**ADDENDUM NO. 1****8/17/2022**

**RE:               McBurney Center Pool Renovation  
Corbin, Kentucky  
Project No. 21140**

**FROM:          Brandstetter Carroll Inc.  
2360 Chauvin Drive  
Lexington, Kentucky 40517  
Phone 859-268-1933  
Fax 859-268-3341**

CP-106 - Pool Piping Plan

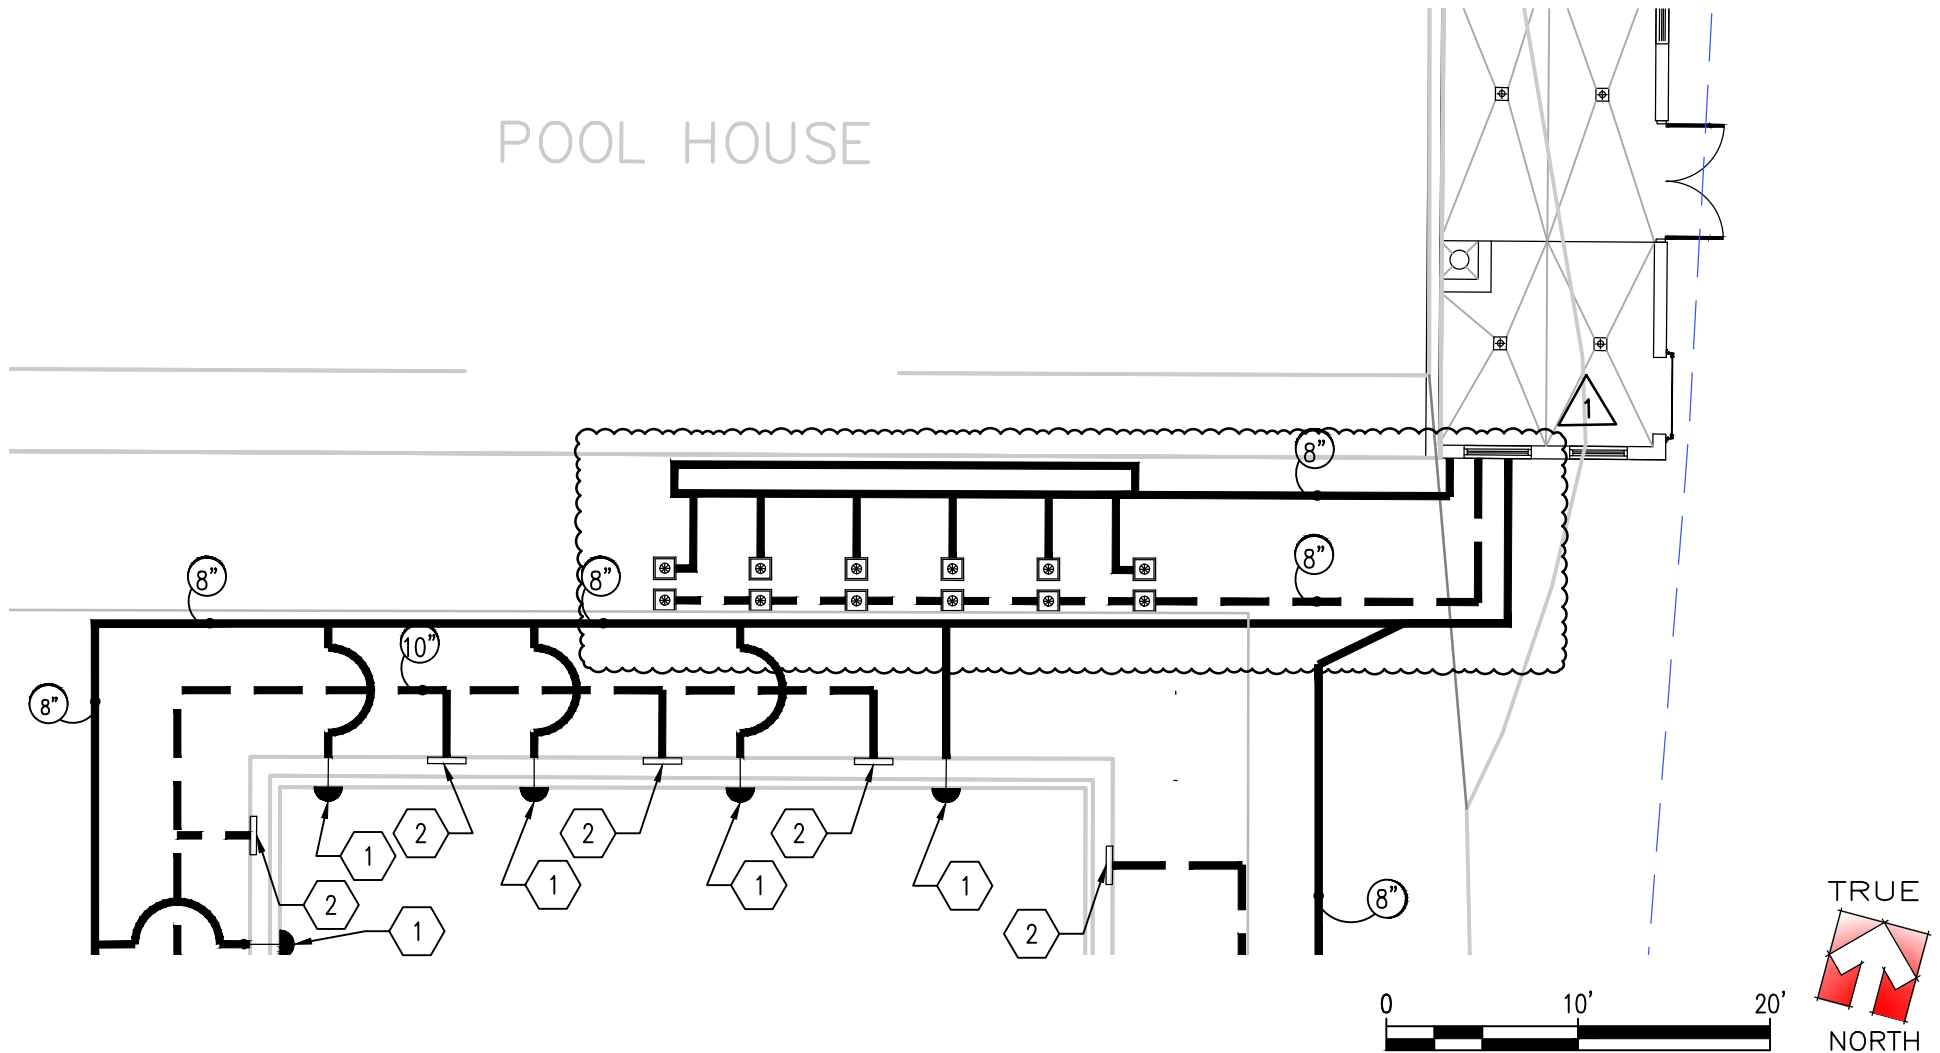
4. CP-106 – Pool Piping Plan
  - A. Added intake and discharge piping and a pressure loop to serve the water lines for the dome heaters.
5. CP-602 – Pool Process Flow Diagram

**Process Flow Diagram - Pools (Lap-Plunge-Activity)**

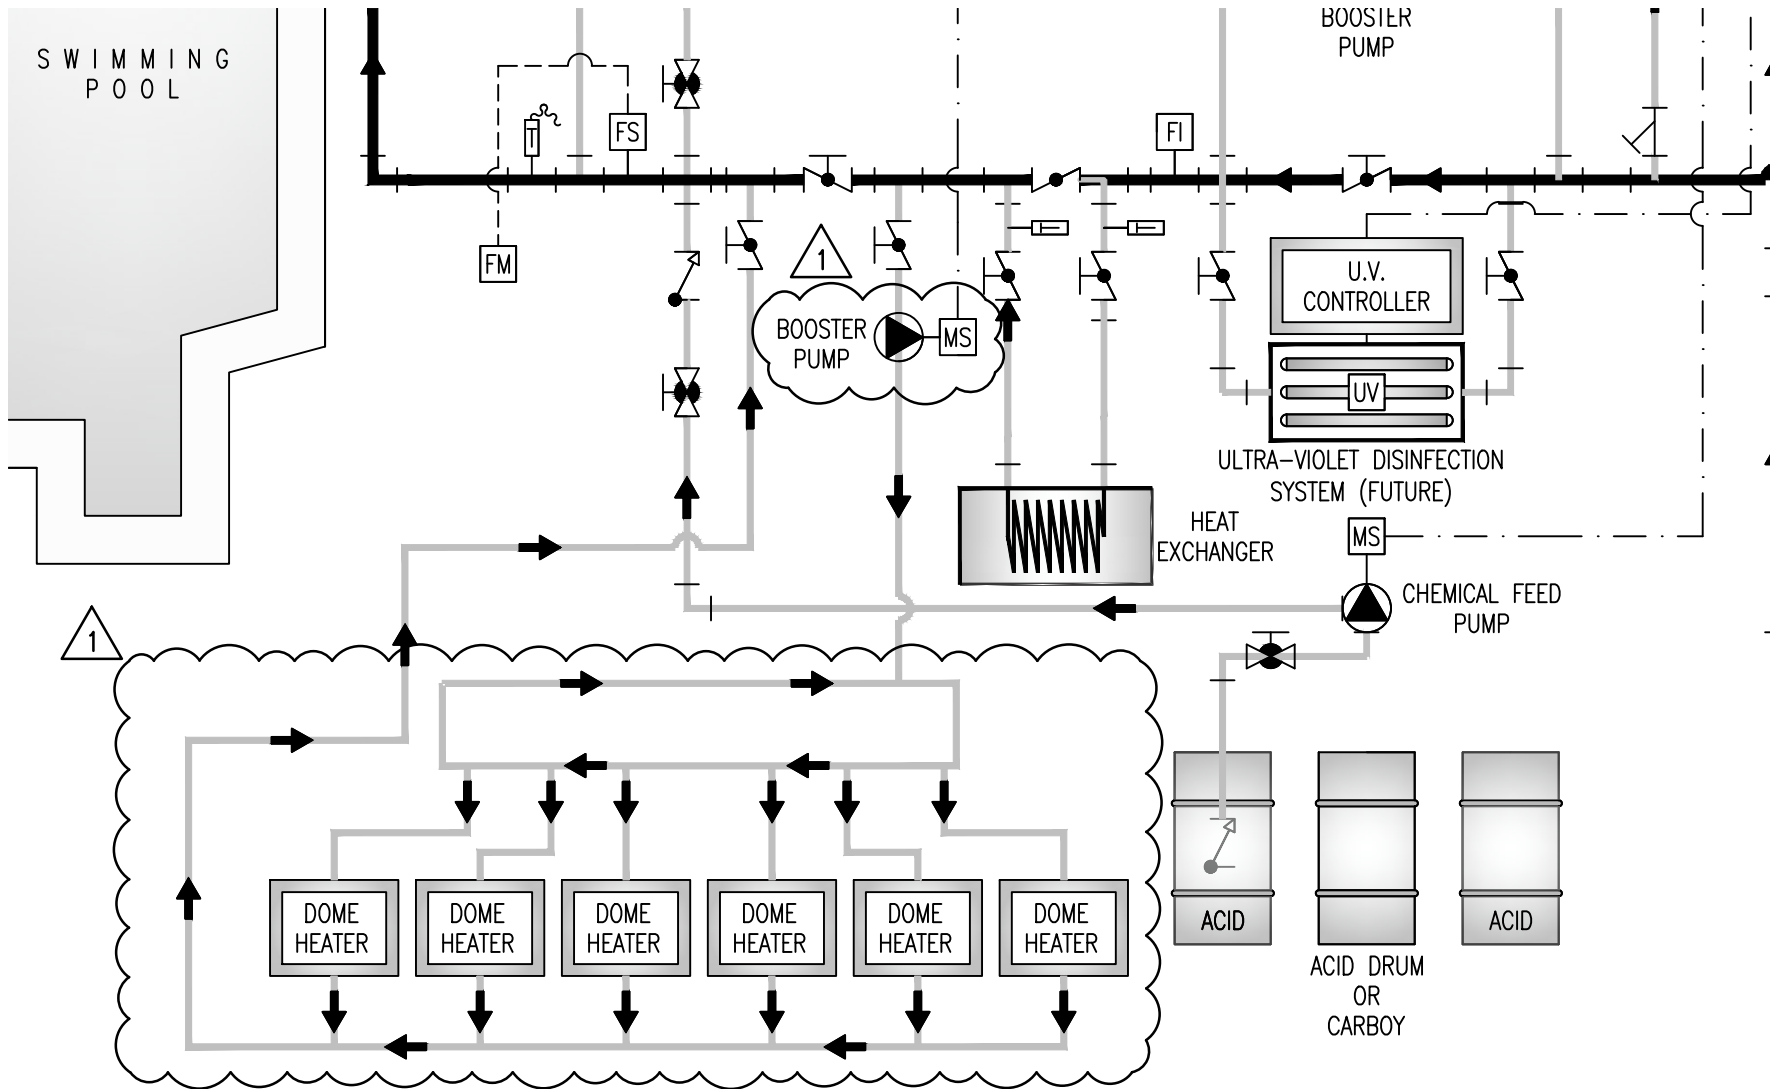
- A. Added a pressure loop and dome heaters to the diagram.
  - B. Added a booster pump to help feed the water flowing to the dome heaters and back. (This will only be used when the dome is in use).
